**Service Bulletin**

Service Bulletin: No. 412-201

**Subject:** 412 Air Conditioner Drive belt replacement procedure, Compressor installation requirements, Refrigerant charging procedures, and Refrigerant Oil verification procedures.

**Applicability:** Bell Model 412EP, S/N 36116 Helicopter which is equipped with Air Comm Corporation Cabin Air Conditioning System; 412AC-100.

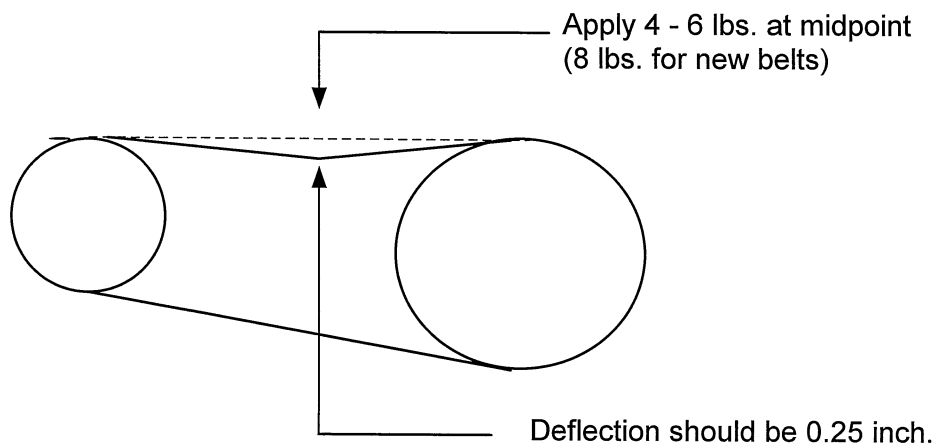
5. Remove old drive belt.
6. Install new drive belt, part number 15542.
7. The required belt tension is 60 lbs. NOTE: Over tensioning will shorten belt life and may damage the clutch bearing. Insufficient belt tension will result in belt slippage, excess heat and reduced belt life. In the absence of a belt tensioning gauge, an approximate adjustment can be made using the following procedure. By applying 4 to 6 lbs. (8 lbs for new belts) force, produces a .25 inch deflection. (see illustration below).

A belt tension gauge should be used to adjust the belt tension (Kent-Moore BT3373F or Equivalent, source: Snap-On tools)

View Looking Down

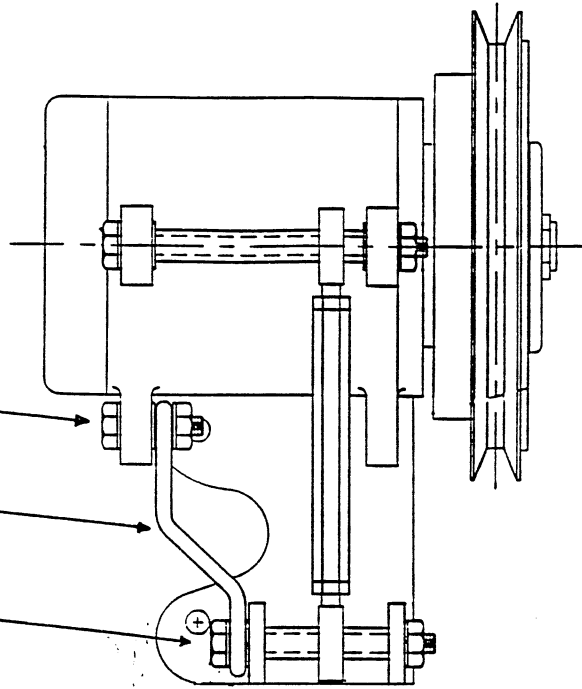
NAS464-P6LA14 Bolt (1)  
MS21042L6 Nut (1)  
(Torque Nut to 95-110 in-lbs)  
AN960-616 Washer (3)

412AC-3014-1 Safety Stop (1)  
(Install Safety Stop as shown)

NAS1306-44 Bolt (1)  
MS21024L6 Nut (1)  
(torque Nut to 95-110 in-lbs)  
AN960-616 Washer (3)

Side View

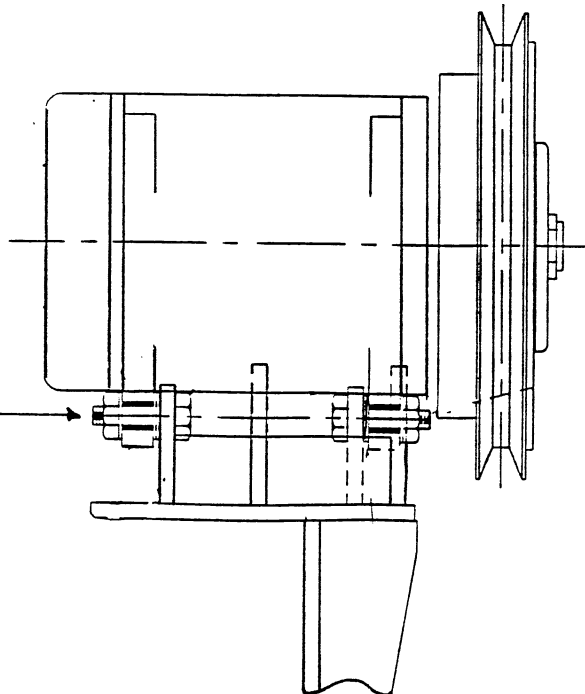
Note: Install washers as required to fill spaces between compressor lugs, and compressor mount lugs. Normally one AN960-616 Washer on each side will be adequate, but due to variations in the thickness of the washers you may need one AN960-616 and one AN960-616L to fill the space between the lugs and mounting ears.

There should be no space between the washer and the mounting lugs. This should be a snug fit, but do not force lugs together.  
(Torque Nut to 95-110 in lbs)

NAS464-P6LA14 Bolt (2)  
AN960-616 Washer (3)  
AN960-616L Washer (1)  
MS21042L6 Nut (2)

Refrigerant Oil Charge Procedure.

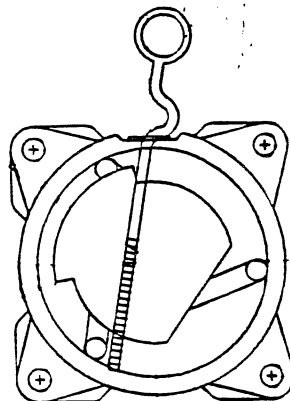
1. Remove refrigerant from the system.  
Note: steps 2, 3, & 4 are required, even if the compressor is to be replaced.
2. Remove the oil filter plug from the top of the compressor body, and check the oil quantity using a dipstick (90916 provided), as shown below.
